Subject: Bear Valley Electric Service, Inc. Response to Notice of Violation- NOV_BVES_CAC15_20231026_1009 (No Written Hearing Requested)

Notice of Violation: NOV BVES CAC15 20231026 1009

After picture of work completed on October 26, 2023

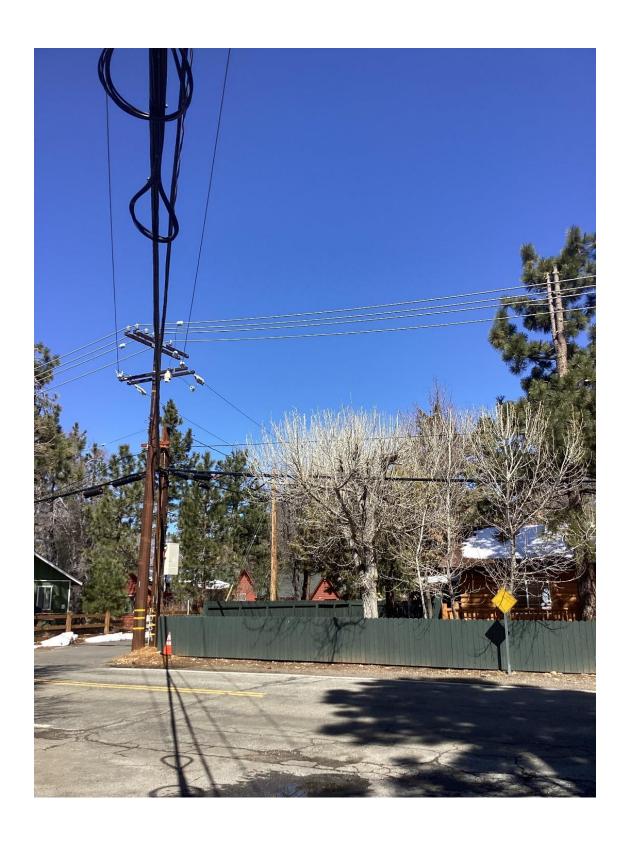
Finding: Near pole ID 15809 at 435-499 Kern Ave, Big Bear Lake, CA, 92386, USA, 34.2430496512049, -116.835088677895, the inspector observed a tulip tree in contact with the primary covered conductor. The inspector's observation is documented in Violation 1 photographs, which are attachments to this report. Photo numbers Item10IA1Img1 and Item10IA1Img2 depict a tulip tree in contact with electrical infrastructure (primary conductor) and within the minimum 72-inch safe clearance distance.

Response: BVES was made aware of the violation by a phone call on October 26, 2023. Crews were dispatched to the location of pole number 1509BV located at (Lat/Long: 34.2430496512049, -116.835088677895). Vegetation crews made corrective trims around the lines near the pole on October 26, 2023. Additionally, when this notice was sent to BVES on March 15, 2024, the lines were re-inspected on for any additional growth. See photos below.
